Revision Transmittal Sheet

SL2026-2

SL2026-2A

PROPELLER COUNTERWEIGHT ATTACH BOLT TORQUE VERIFICATION

Figure 1. (Sheet 1)

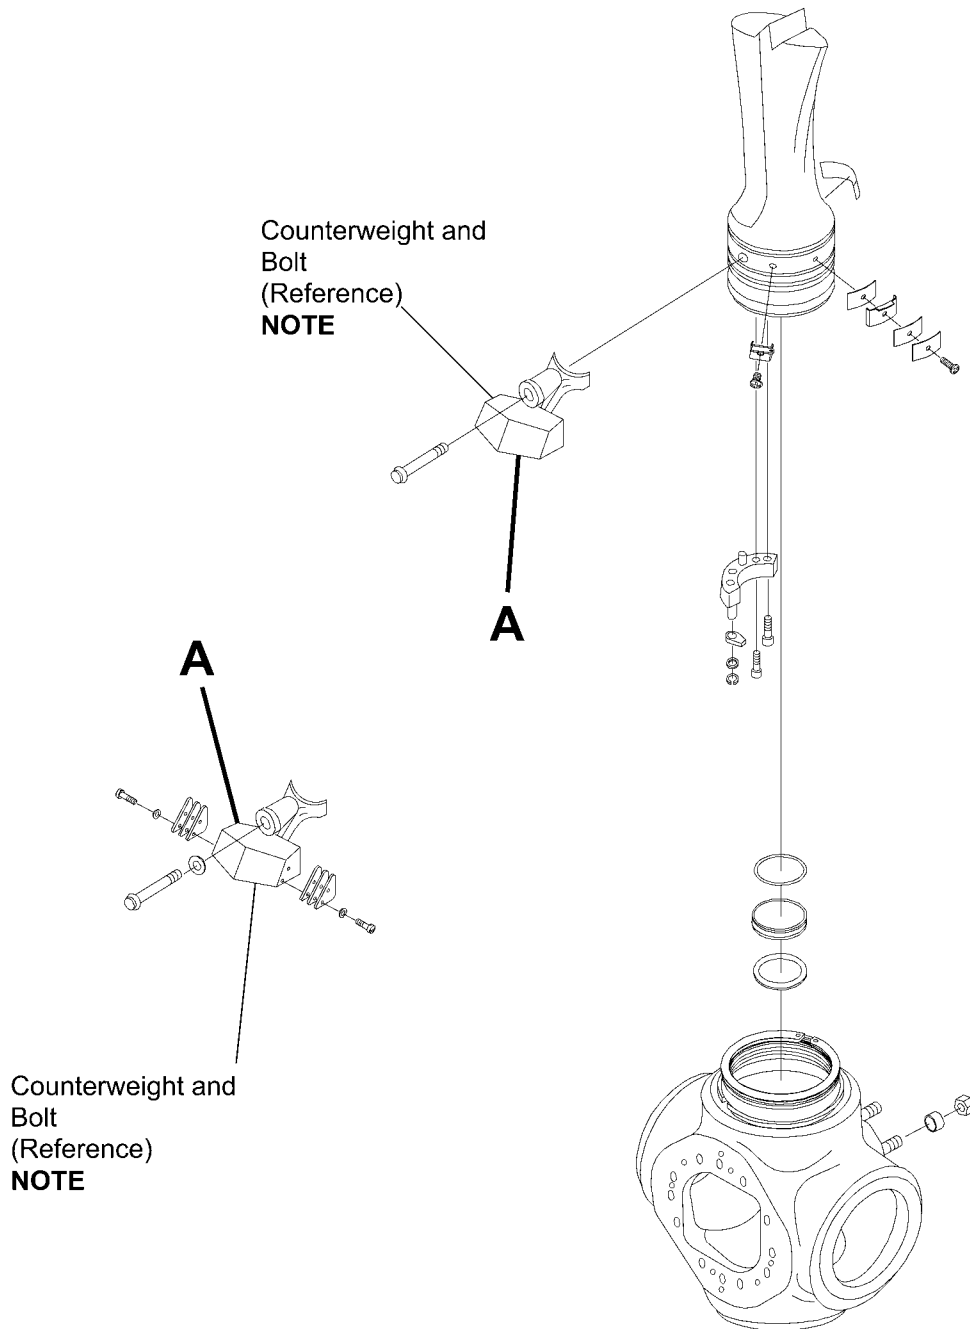
1. Remove the spinner from the propeller to gain access to the propeller counterweights. (Refer to the applicable Aircraft Maintenance Manual.)
2. **Field Work Instructions:**
 - A. (Refer to Figure 1, Sheet 1.) Verify the counterweight attach bolt torque of each propeller as follows:
 - (1) Set a torque wrench to the necessary value 'Torque Check Value' for the model of propeller (Table I).

- (2) Using the torque wrench, check each counterweight attach bolt.
 - (a) If one or more bolt(s) is below the "Torque Check Value", verify if the propeller has accumulated any hours of engine run or flight time.

- (c) If all bolts are above the 'Torque Check Value', go to step 2. B.
- B. Torque the counterweight attach bolts of each propeller as follows:
 - (1) Set a torque wrench to the 'Required Torque Value' (Refer to Table I).

NOTE: All C600 Series Propeller Torque Check Value is 60.0 Ft-lbs.
